February 1, 1993

RE: - HPS Post Certification Modification.

Per your instructions, I have enclosed drawings and tables indicating the changes to the wetland impacts and wetland mitigation associated with the Hardee Power Station to Lee Substation. These changes involve a variety of items including eliminating errors on drawings, replacing corduroy roads with culverts or replacing culverts with corduroy roads, adding culverts in roadside ditches where alternate access was not available, and modifying the restoration and creation areas to comply with SWFWMD and FG&FWFC requirements. The information for culvert sizing and changing corduroy roads to culverts has been submitted and approved by SWFWMD. Under condition XXXV C. 1. c. the culvert/corduroy road activities have been determined by SECI to be minor field changes and therefore may not require a modification to our post certification approvals. The changes to the restoration/mitigation area are relatively minor changes as required by other agencies and therefore may or may not require DER approval.

DITCH "2D11, 12, 13" PLAN/PROFILE

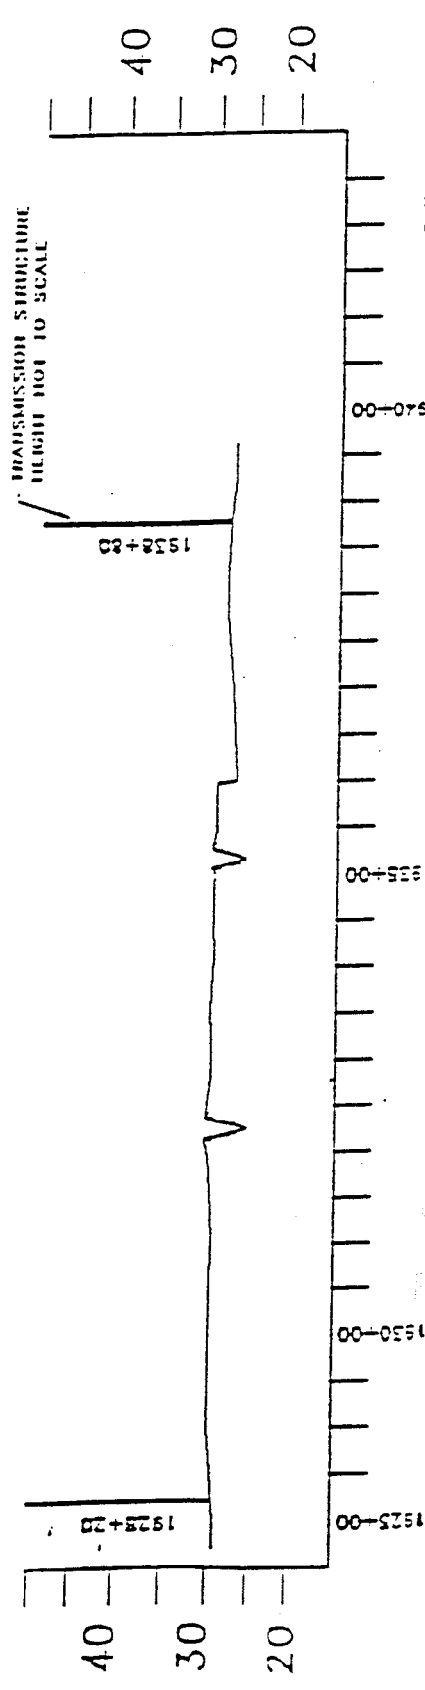
- . Wetland 2D-11 had forested clearing impacts not previously recognized but fill was no longer required in the upland ditch.
- . Wetland 2D-14 had forested clearing impacts not previously recognized.

DITCH "2D15" PLAN/PROFILE

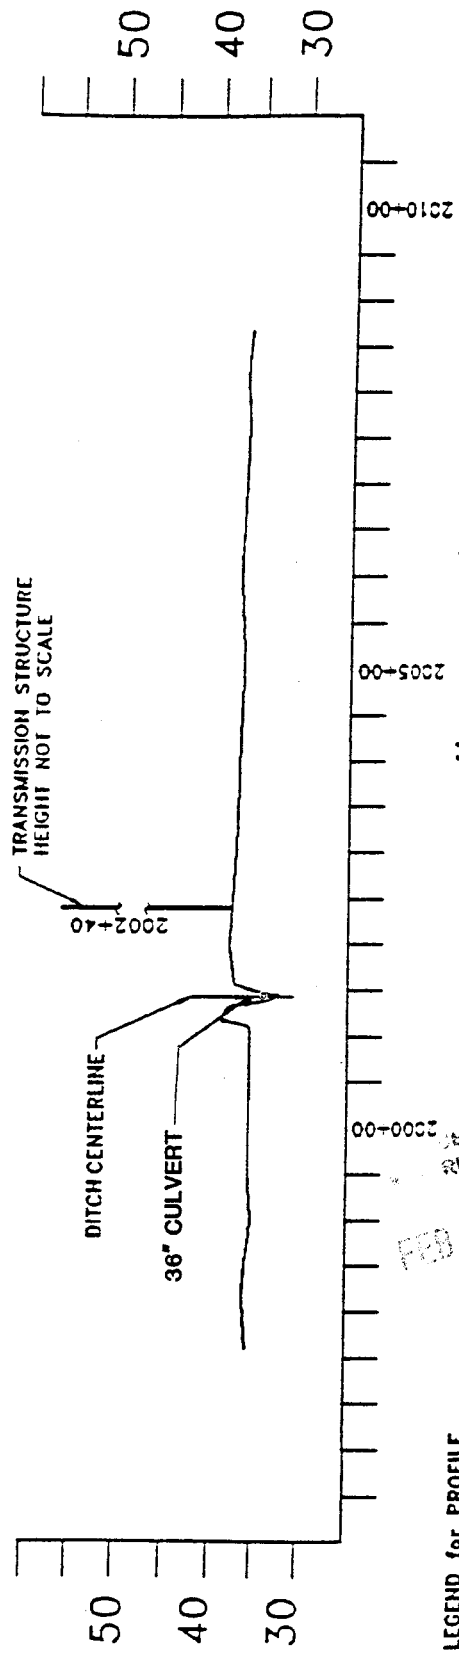
- . Wetland 2D-15 had no changes but the drawing had culvert sizes added.
- . Ditches 2D-17 and 2D-18 no longer require the corduroy roads initially approved.

WETLAND "2D19/20"

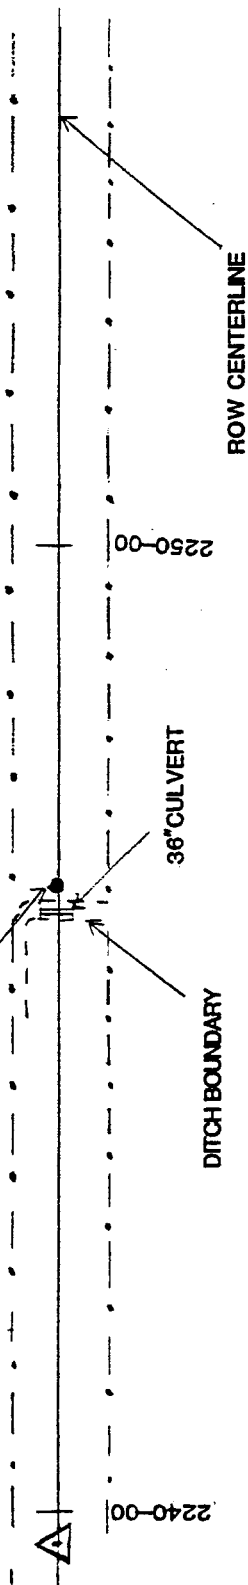
- . Wetland 2D-19-20 had the corduroy roads originally proposed replaced with culverts due to construction requirements.
- . Ditch 2D-22A was required to have a culvert and associated fill although it was had previously not required fill.

DITCH "2D23"
 PLAN/PROFILE
 SCALE: 1"=200'

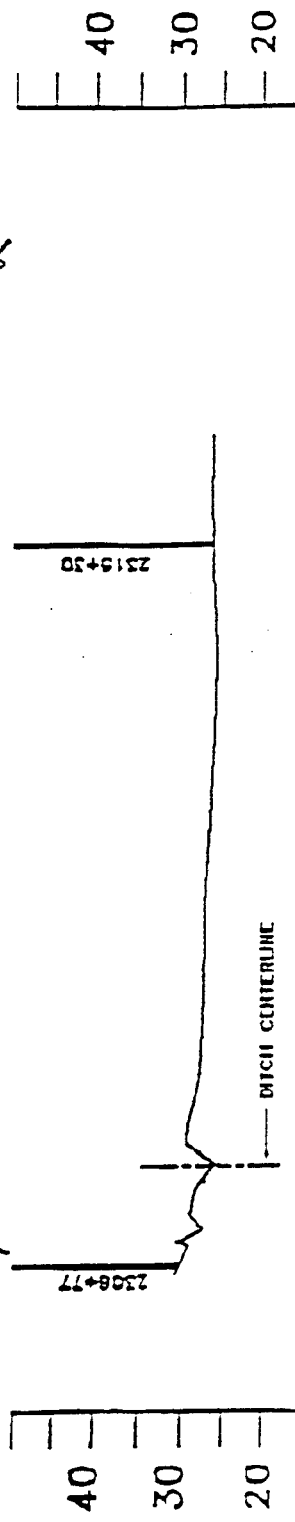
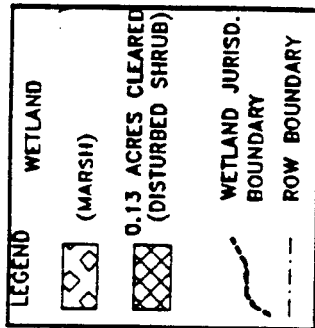
- . Ditch 2D-23 had decreased fill impacts due to access being limited to the existing low water crossing on a tributary to Prairie Creek.
- . Wetland 2C-26 had no changes but graphical errors were corrected.

WETLAND "2C32A"
PLAN/PROFILE
SCALE: 1"=200'
FEB 14 1993
REC'D
WET. RES. DIV.

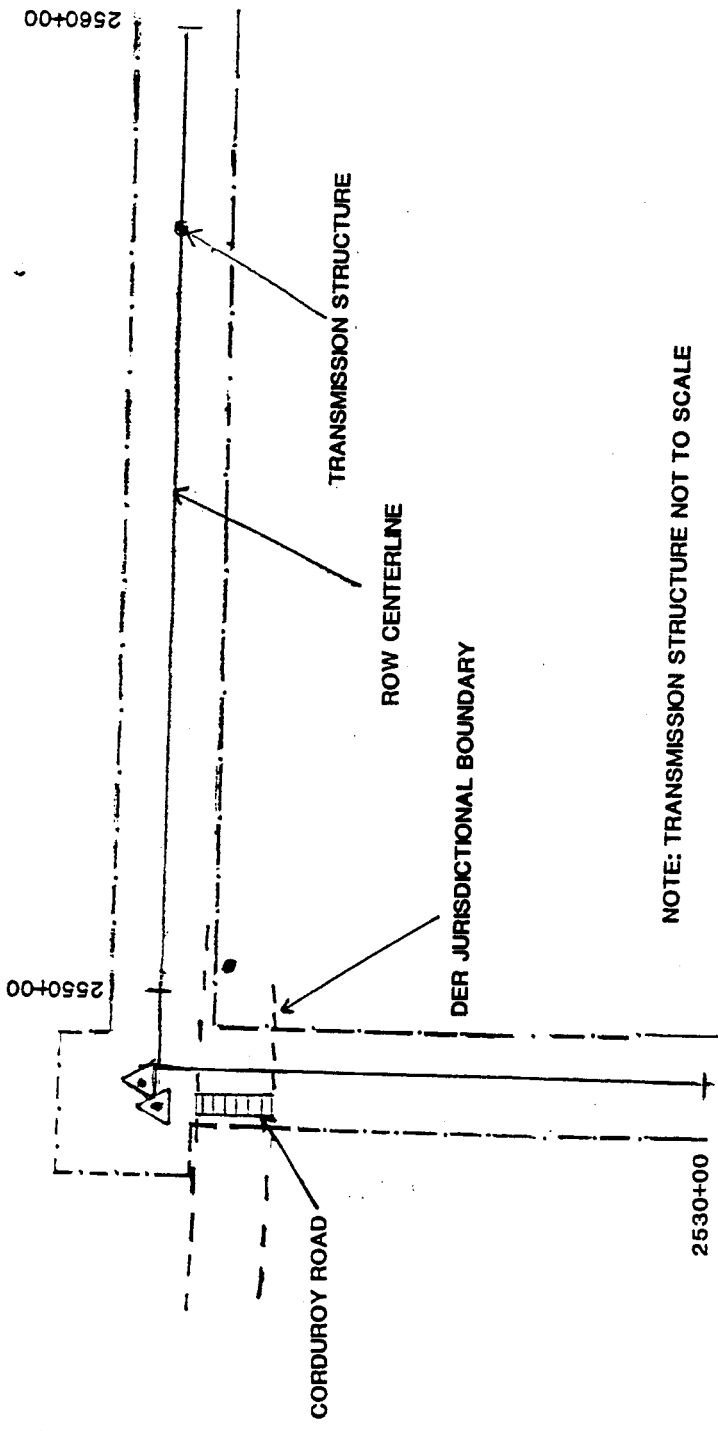
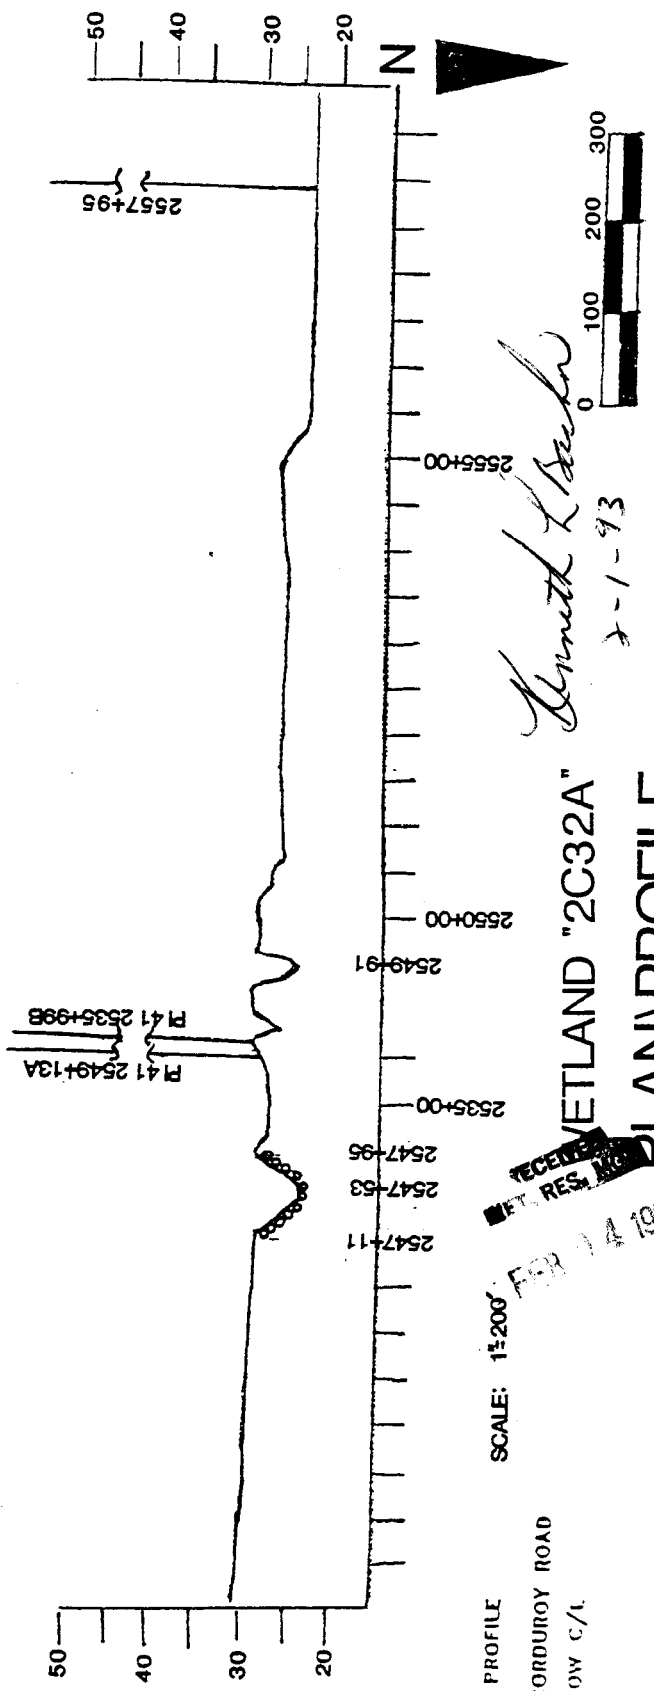
- . Ditch 2C-32A was added and required a corduroy road.
- . Wetland 2C-32 was changed to 2C-32B for clarification and the corduroy road impacts were limited to lesser acreage.

WETLAND "2C32C"

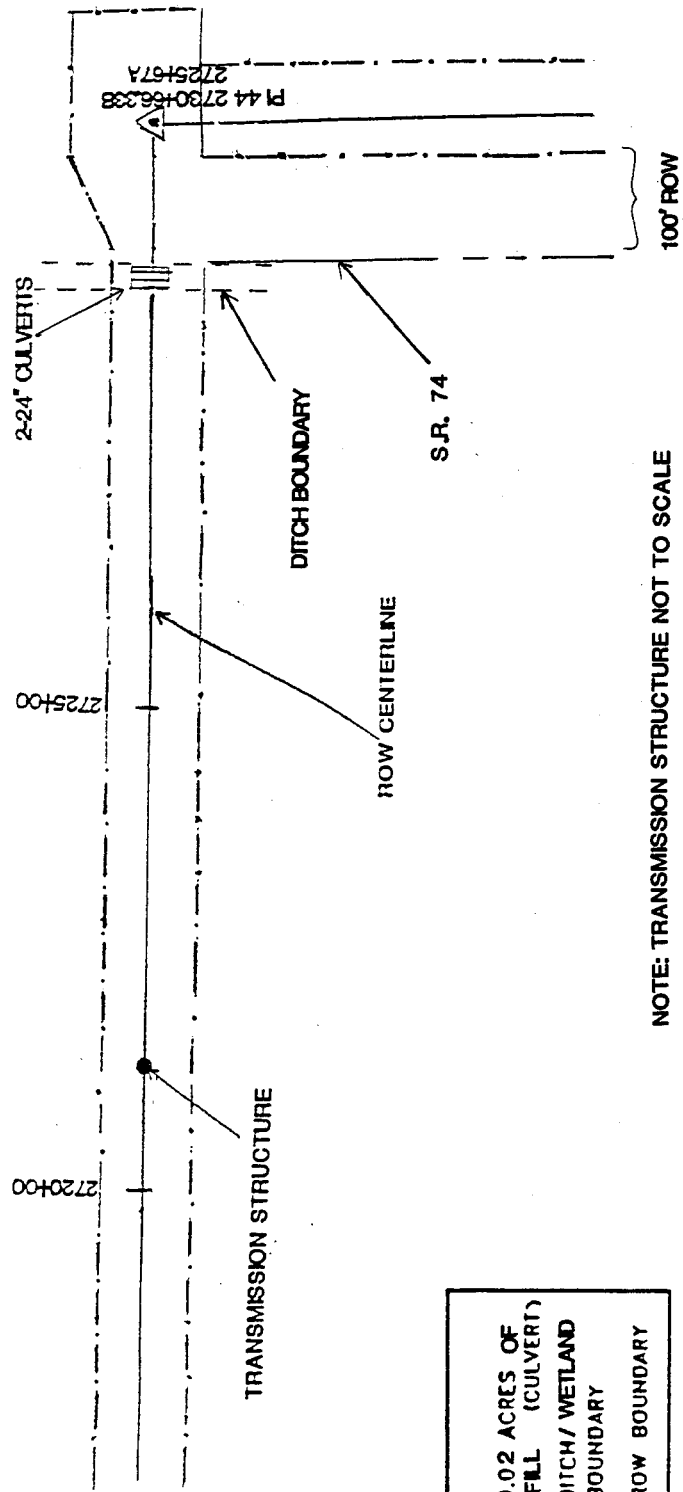
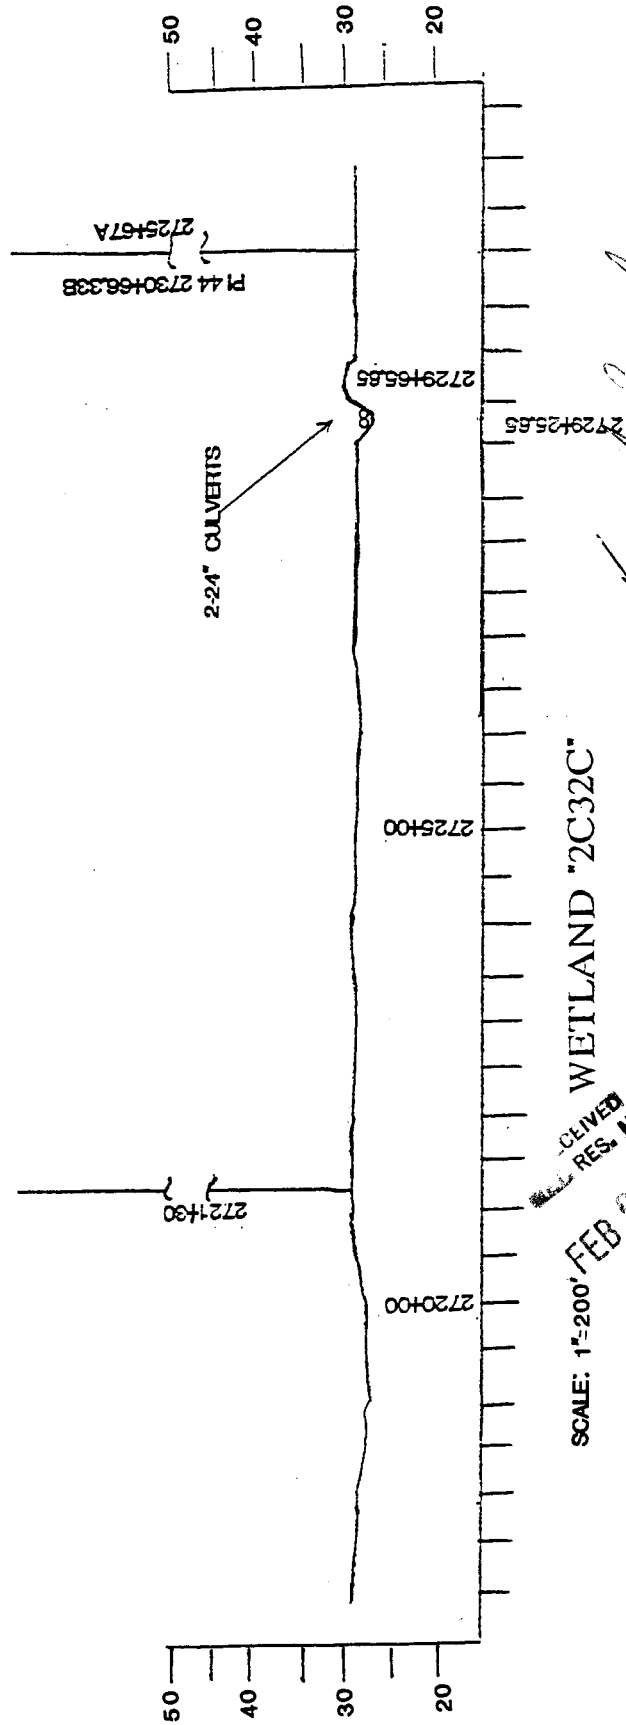
- . Roadside ditch 2C-32C was added and required a culverted road.
- . Wetland 2L-80 had no changes but had graphical errors corrected.
